Mad Moose Wall Design Review

Mad Moose Café

New Wall / Sliding Window Layout

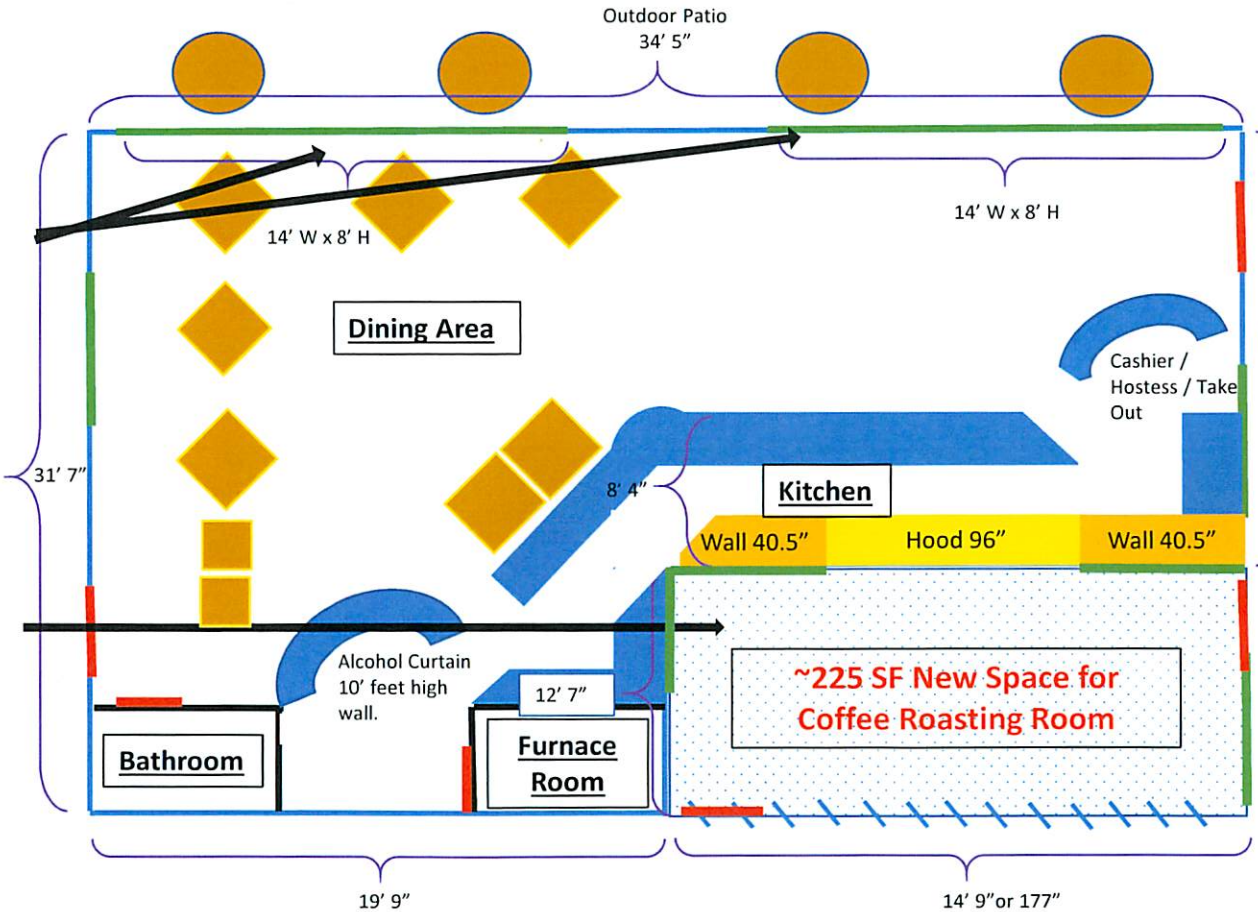
4.) Change 4 of 4: Improvement of internal “non-load bearing wall” to increase Mad Moose space 225 SF. Change involves addition of one non-loadbearing wall, two doors, and four windows for customer viewing, and to permit coffee bean roasting and packaging, and school and customer tours. To be completed within 18 months of Design Review approval. Mad Moose Coffee roasting process complies with Utah Departments of Agriculture and Health requirements for bean roasting & packaging, including periodic regulatory inspections.

Specifications: 1. Install two sliding door systems 8'h x 14' w marked in green on east facing wall. 2. Add ~225 SF add'l space indicated by "dotted" area in SW corner of café.

1. New Sliding Window / Doors
(Location Depicted by two solid green lines on east facing wall.)

2. Additional Space
West of Hood "dotted" ~225 SF. Includes two new doors in red, new windows depicted in green. Windows added for customer viewing from within café. No walls removed, only 1 wall, 2 doors, 4 windows added to new room (New wall indicated by hash marks).
